Field campaign

Topic	Vehicle emission control information label - Emission service action (SC20/10)
Market area	United States E05 Bentley USA and rest America (6E05)
Brand	Bentley
Transaction No.	2059179/1
Campaign number	EB52
Note	
Type	
US code

New Continental GT and New Continental GTC

Figure 3

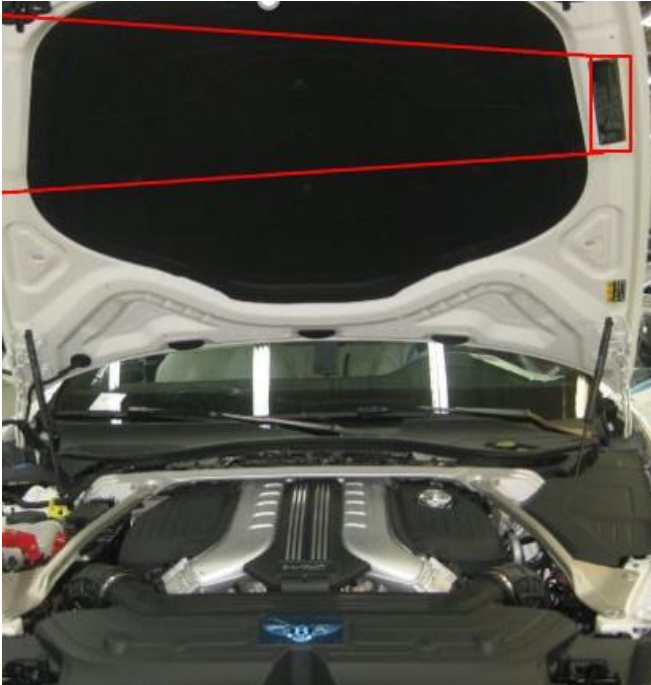
1. Using a plastic spatula/wedge, slowly remove the label located as shown in Figure 3

2. Using a proprietary solvent and a lint free cloth, remove the leftover adhesive until completely clean.

3. Before fitment of the new label commences ensure the painted surface is completely dry.

4. Applying sufficient pressure, fit the new label to the same location as the removed label.
